DEVELOPMENT REVIEW BOARD REPORT

33-DR-2005
Fairmont Scottsdale Princess Mixed Use Project

Request approval of the site plan and elevations for Phase One (Retail & Office Buildings) of a larger master plan.

SITE PLAN

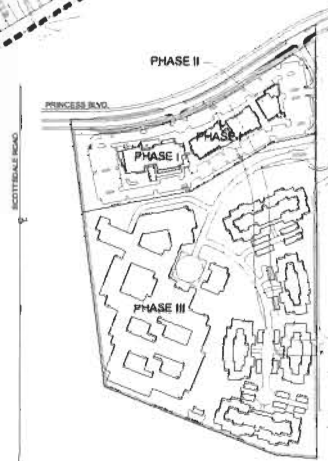
17. The site plan and phasing shall be revised as necessary to include the construction of vehicular and pedestrian circulation facilities as necessary to connect the proposed improvements to existing resort facilities and buildings adjacent to the West. The connections shall be constructed with Phase I. These revisions shall be subject to a new DRB hearing or staff approval, as determined by the Zoning Administrator.

19. The site plan shall be revised to accurately indicate the limits of construction, consistent with the stipulations herein.
- B. No Phase II improvements are part of this approval. At the time of final plans submittal, all site plan and other submitted document content shall be revised to accurately reflect the Phase I only approval.

- I. In accordance with the stipulations of 1-ZN-2003, the site plan and phasing shall be revised to include pedestrian facilities to connect the proposed improvements to existing resort facilities and buildings adjacent to the west. The connections shall be constructed with Phase I.

- K. In accordance with the stipulations of 1-ZN-2003, the site plan and phasing shall be revised to include automobile circulation facilities to connect the proposed improvements to existing resort facilities and buildings adjacent to the west. The connections shall be constructed with Phase I.

- L. The site plan shall be revised to indicate the limits of construction consistent with all Zoning Ordinance requirements and the stipulations of Zoning Case 1-ZN-2003.

- P. The site plan shall be revised as necessary to demonstrate full Americans with Disability Act compliance, and compliance with the City of Scottsdale Zoning Ordinance requirements for handicapped parking.

PLANTING PLAN
DESIGN REVIEW SUBMITTAL

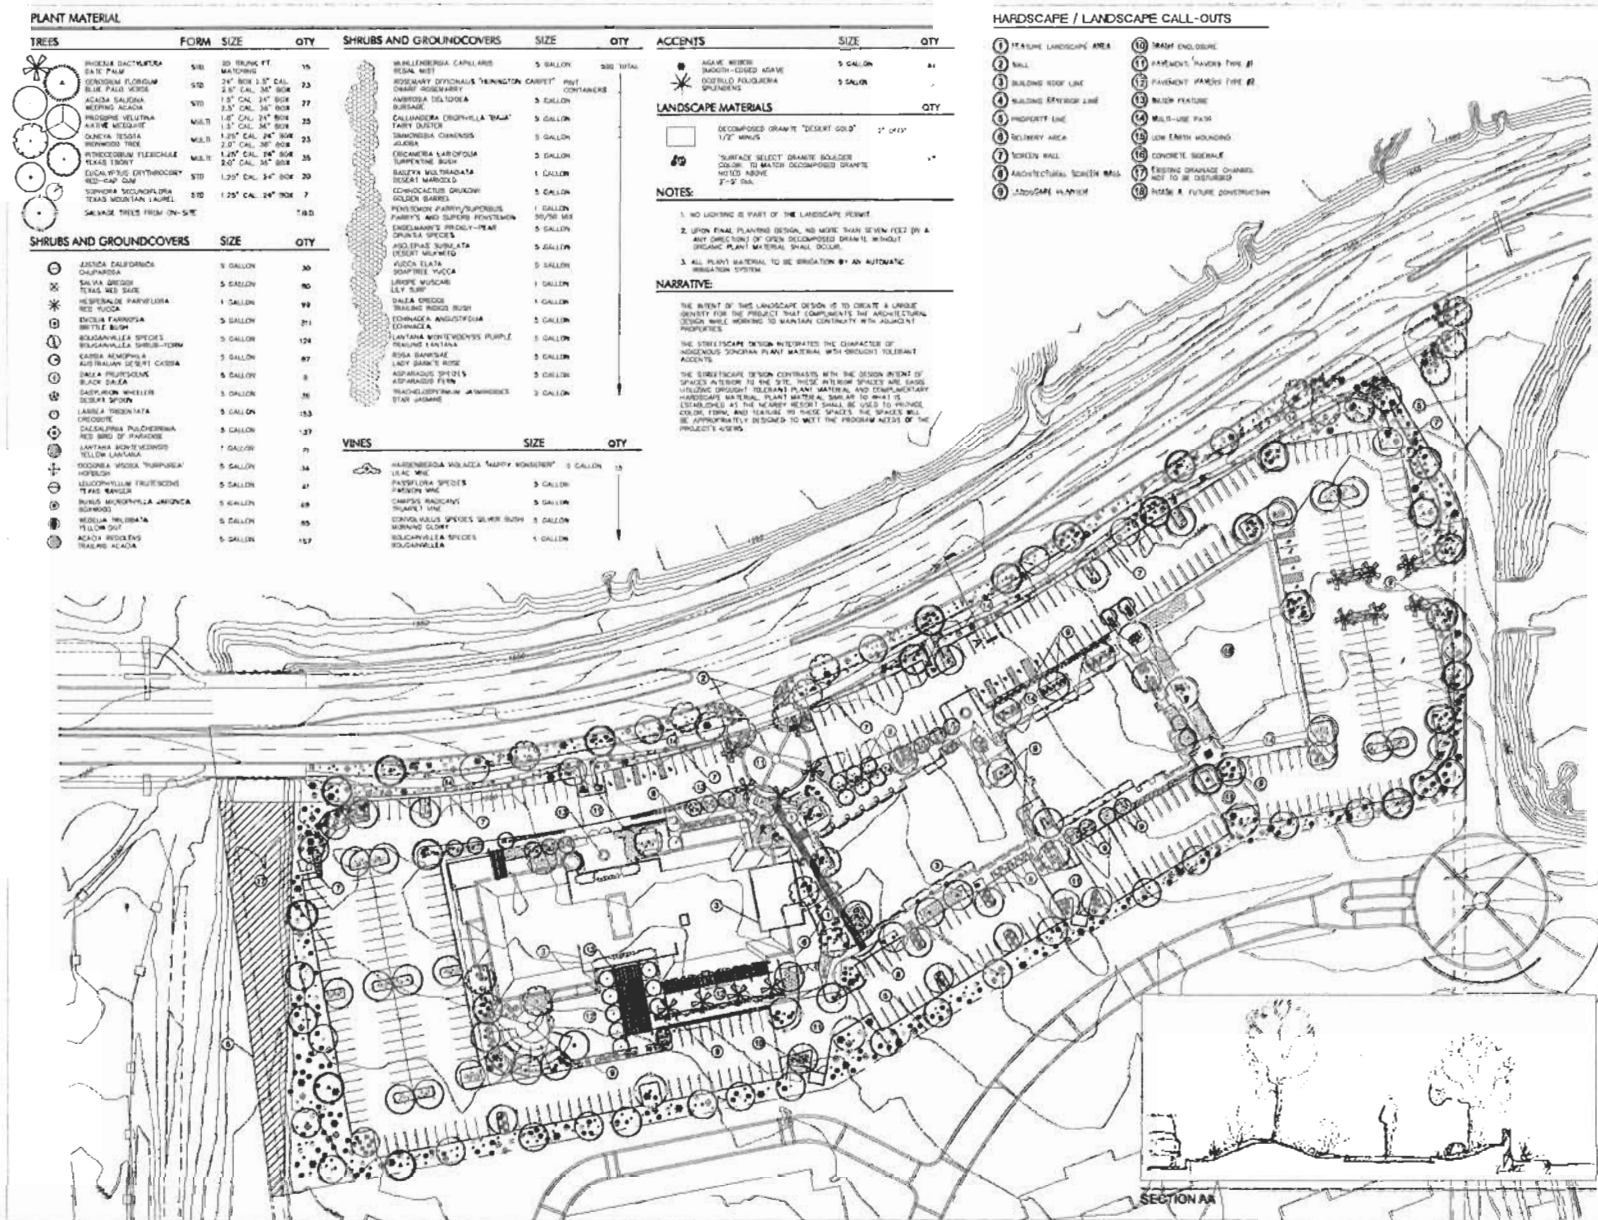
- 21. Landscape plan notes are not a part of this approval.
- 22. Tree box size shall be consistent with the Arizona Nursery Association standards for the listed species and caliper.

- 29. Landscape plans shall be revised to include treatment for all areas disturbed by all Phase I improvements, including improvements stipulated herein. The revised landscape plan shall be subject to staff approval.

- Q. Planters and landscaping shall not obstruct pathways as required by the regulations established for the Americans with Disabilities Act.
- R. The landscape plan shall be revised as necessary to differentiate between existing species to remain, existing species as relocated, and new material. Protected native species shall be specifically identified on the plan.

- T. Fifty percent of trees shall be mature as defined in Article III of the Zoning Ordinance.
- U. The landscape plan planting legend shall identify the quantity, size, botanical name, and common name of all plants. Tree size shall be indicated in caliper and box size.

- W. Areas of mass plantings of shrubs and ground covers must have a maximum spacing of four feet on center in the Rights-of-Way, and seven feet between projected mature canopies on-site. Rights-of-Way include easements for roadway and other easements serving as principle means of access on and off-site.

- X. Landscape plans shall be revised to include all areas disturbed during Phase I construction as stipulated elsewhere herein, as required by the Zoning Ordinance, and as required by Zoning Case 1-ZN-2003. These revisions shall be subject to staff approval.

WEST WING ELEVATIONS
OVERALL

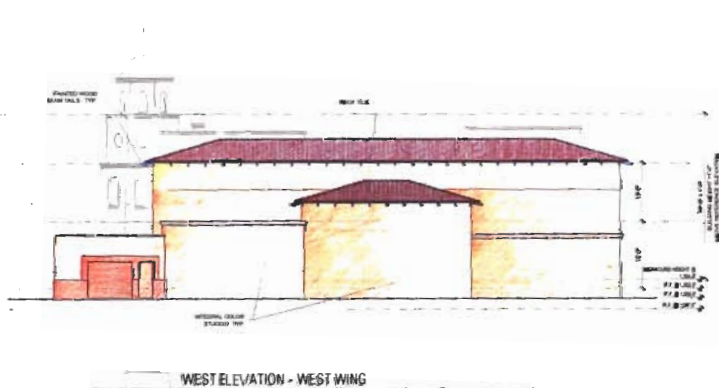
- a. Architectural elements, including dimensions, materials, form, color, and texture, shall be constructed to be consistent with the West Wing Elevations - Overall and East Wing Elevations - Overall submitted by Allen + Philp architects with a staff receipt date of 4/29/2005.
